CITY OF VANCOUVER

POLICY REPORT URBAN STRUCTURE

TO: Vancouver City Council
FROM: Director of Current Planning
SUBJECT: 1750 Davie Street: Rezoning from C-5 to CD-1

GROUND FLOOR PLAN

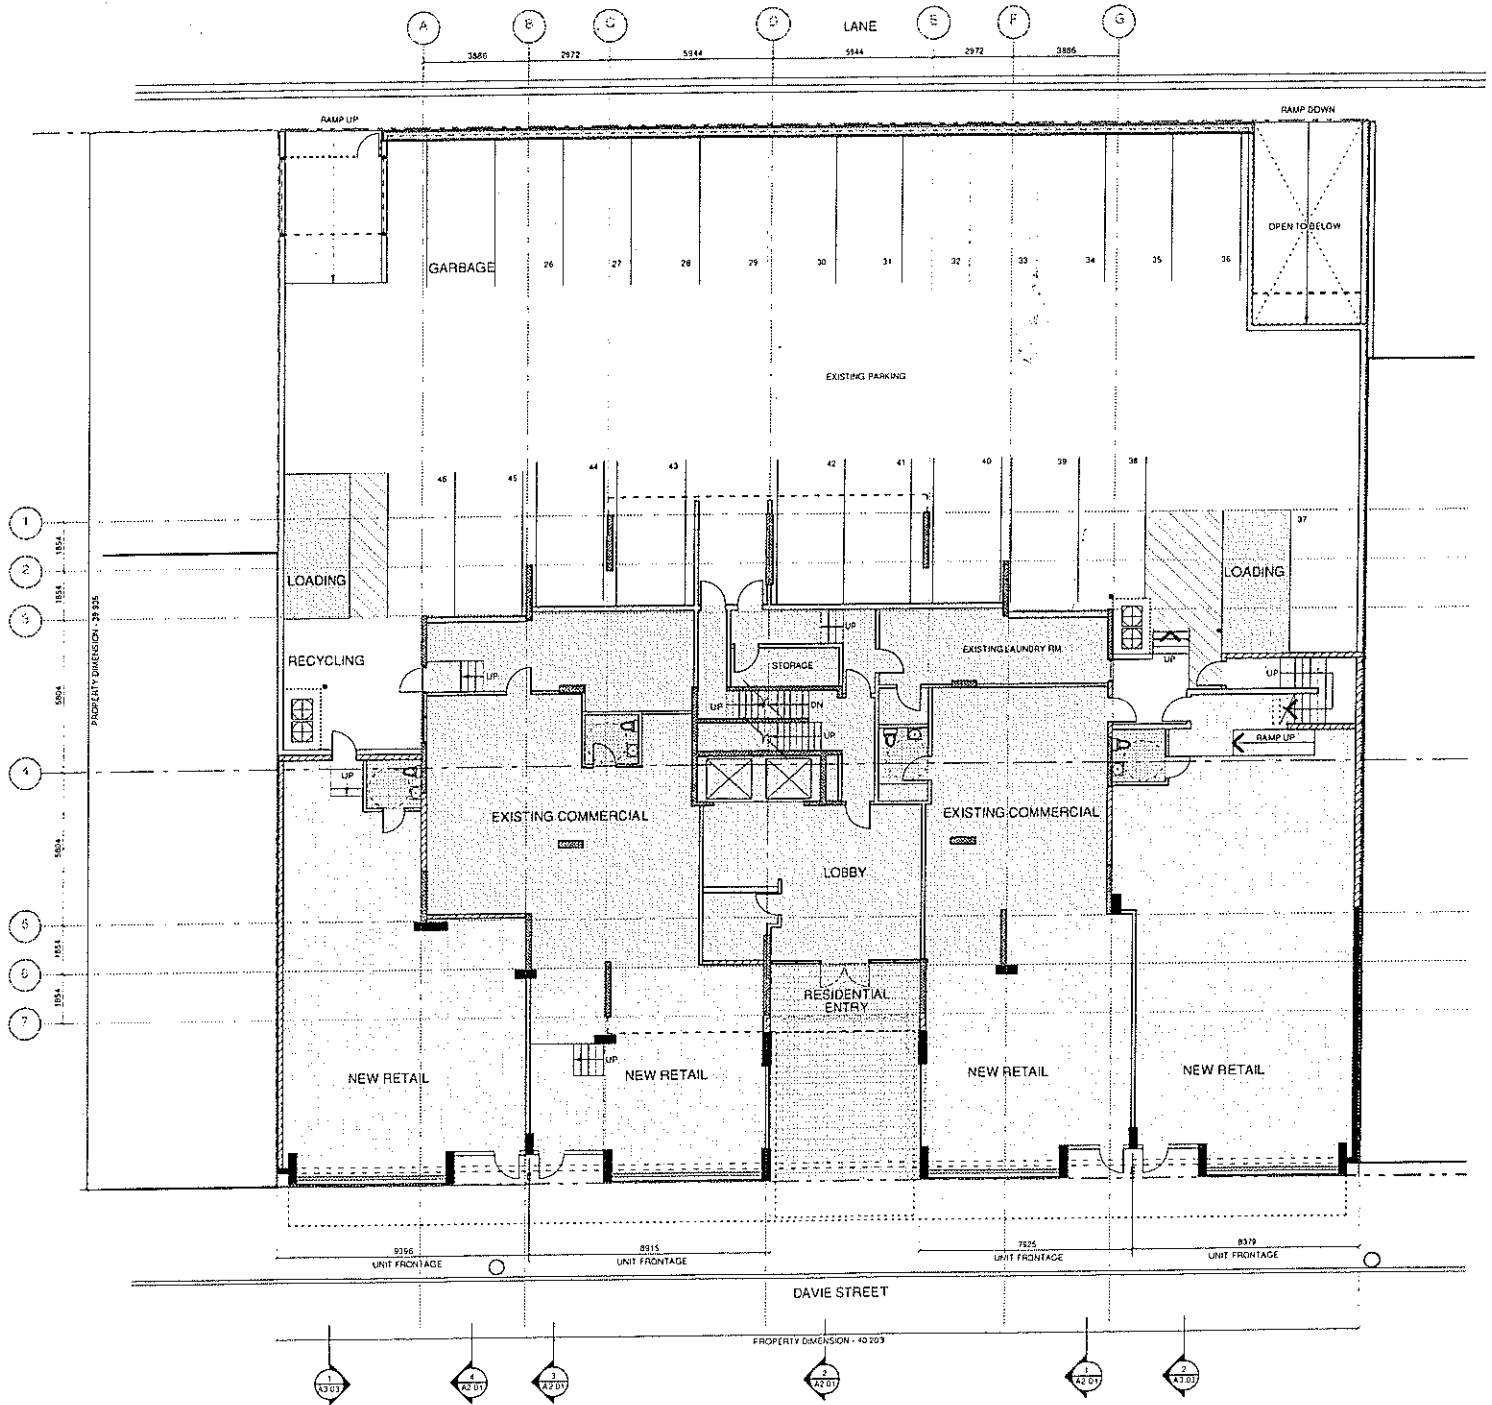
- (i) design development to improve the small-scale retail rhythm of Davie Street;

Note to Applicant: The continuous horizontal fascia and associated planter can break at the residential entrance, and other enhancements in consultation of the C-5 District external design regulations.

- (ii) design development to improve the residential entrance;

Note to Applicant: The entrance doors could be closer to the street and the retail glazing wrapped at the corners, and other enhancements in consultation of the C-5 District external design regulations.

The Panel had concerns about the residential entry, in particular with respect to security because it will likely attracted unwanted overnight guests as currently designed. Several Panel members suggested a courtyard entry would be a better solution.

SECOND FLOOR PLAN

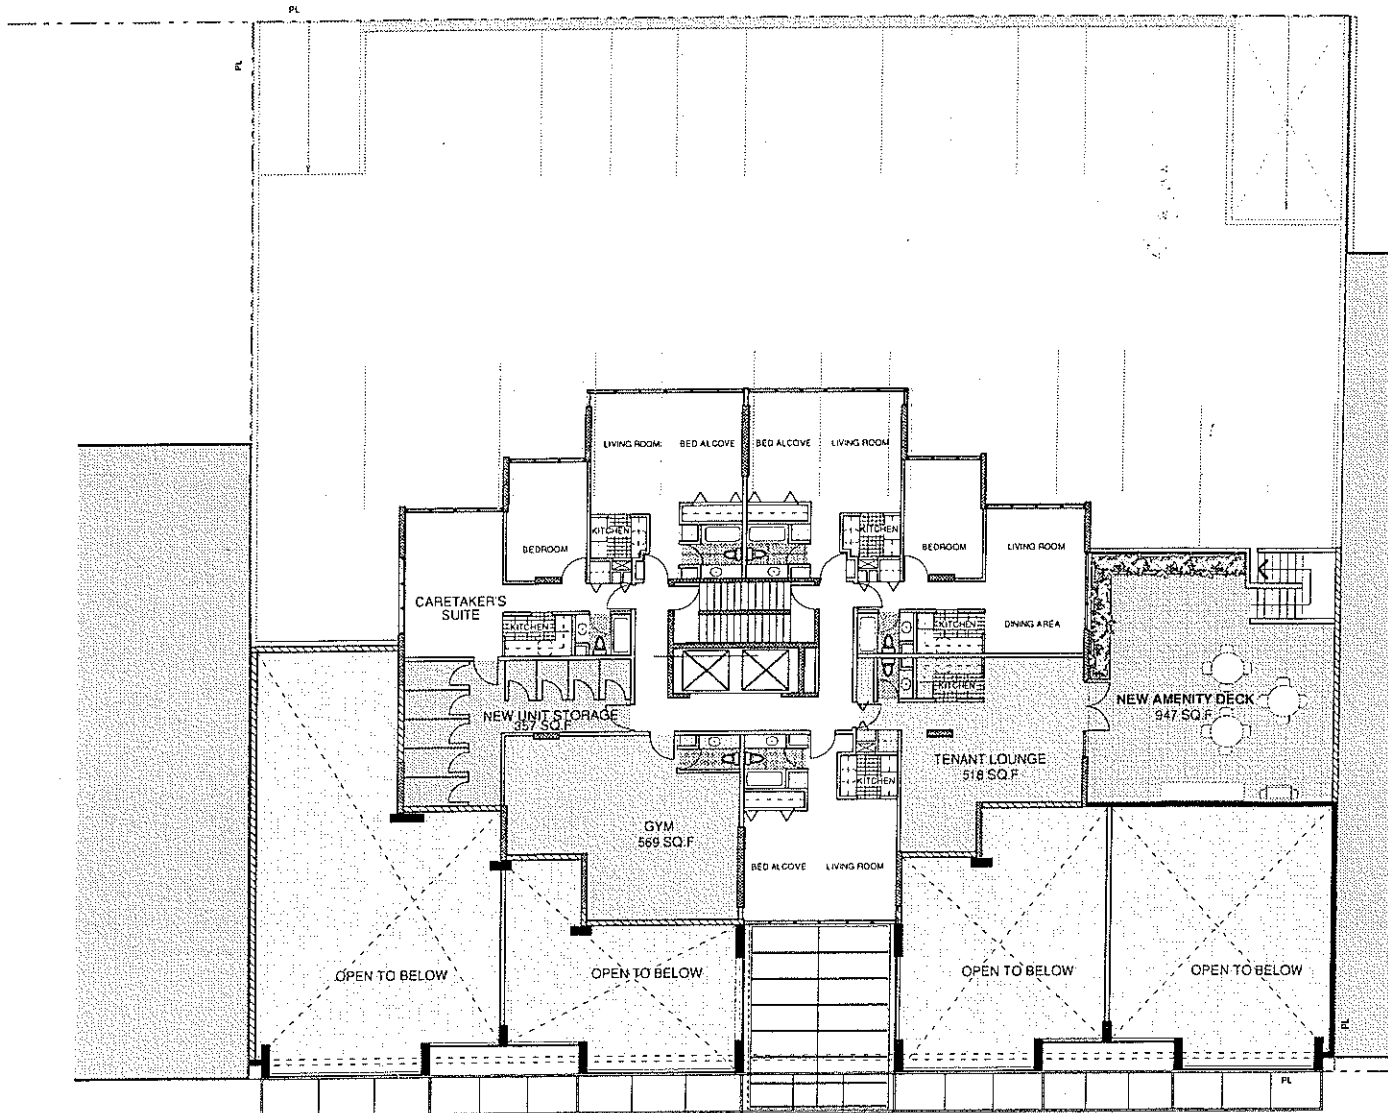
- (vii) More substantial roof top planting on the second floor amenity roof deck should be considered (and incorporating larger planters and small trees);

Careful attention should be given to the west wall screening the outdoor amenity space to improve its liveability. Attention should also be given to overlook of the commercial roof. Surface patterning or planting should be considered.

NORTH ELEVATION – Davie Street

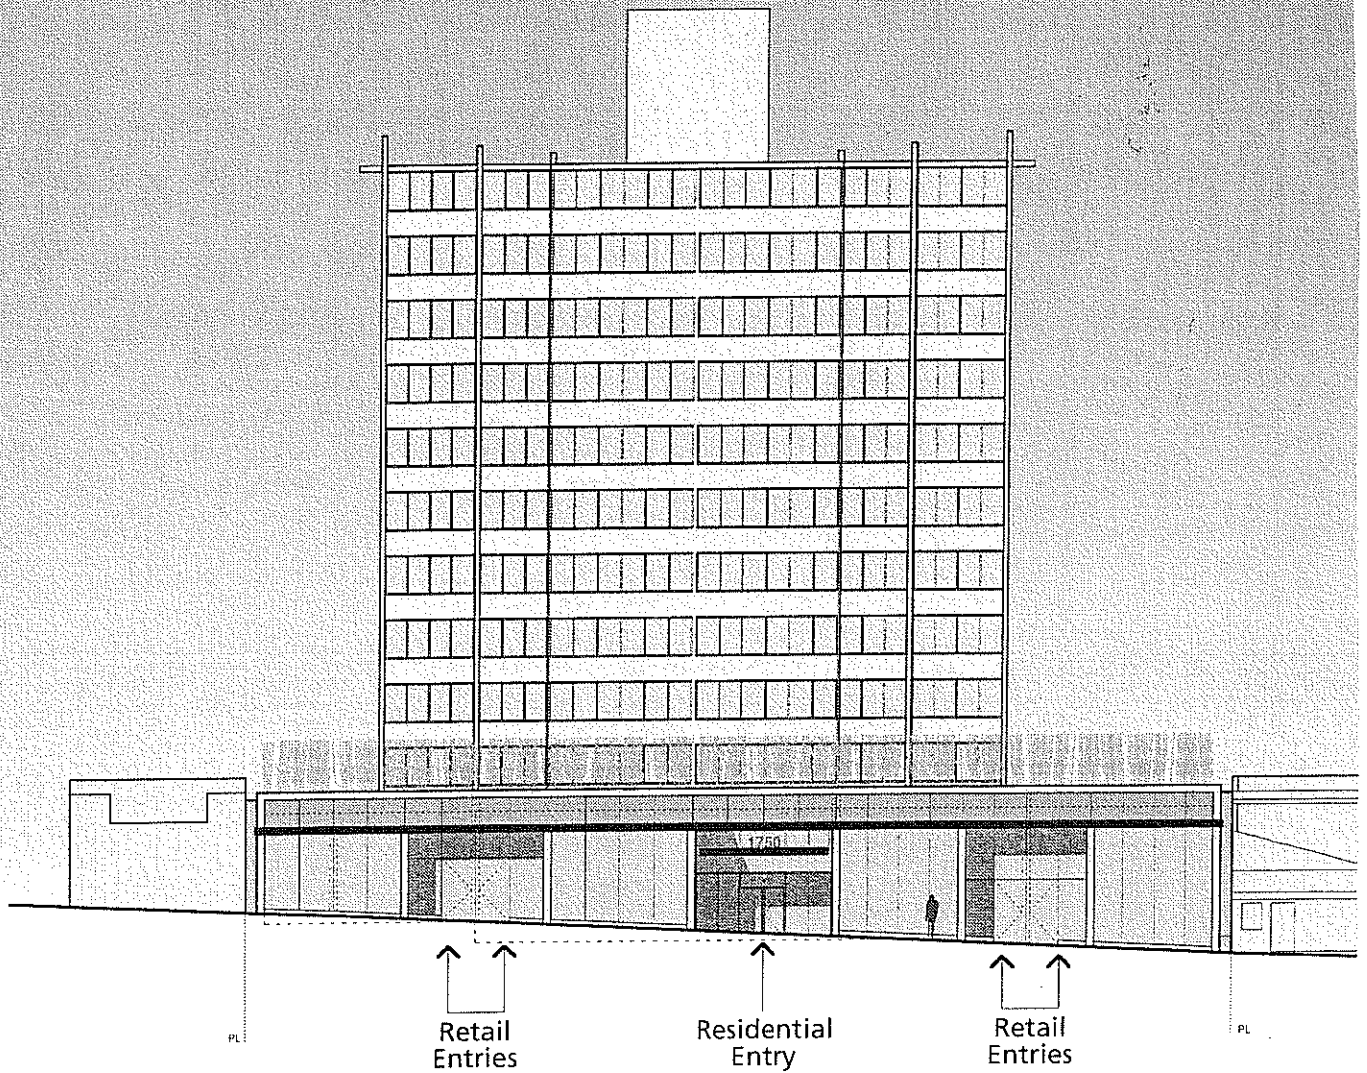
Concerns were expressed about the treatment of the facade, although one Panel member thought its horizontality was a legitimate architectural response. However, most Panel members thought it should better reflect the incremental nature the Davie Street frontage

and be broken up more. Design development was recommended to provide greater opportunity for individual store expressions. One Panel member acknowledged the horizontal element brings the two neighbours together but thought there could be some articulation or change of materials at the entry. There were also comments that the building needs to be more playful, warmer and more inviting. One Panel member did not support reflecting the horizontal banding of the 60's tower the commercial addition but recommended considering it as two projects: a residential tower at the rear and a streetscape urban design exercise at the front. Questions were raised about the row of bamboo, which contributes to the monolithic appearance of the building. More landscape details will be necessary at the next stage of the design. Another Panel member questioned whether the bamboo will achieve the crisp horizontality suggested in the illustrations; some other plant material might be better.

Design development to the canopy was recommended, and to bring it down to a level where it is more effective as weather protection. Signage will also need to be carefully considered at the development application stage.
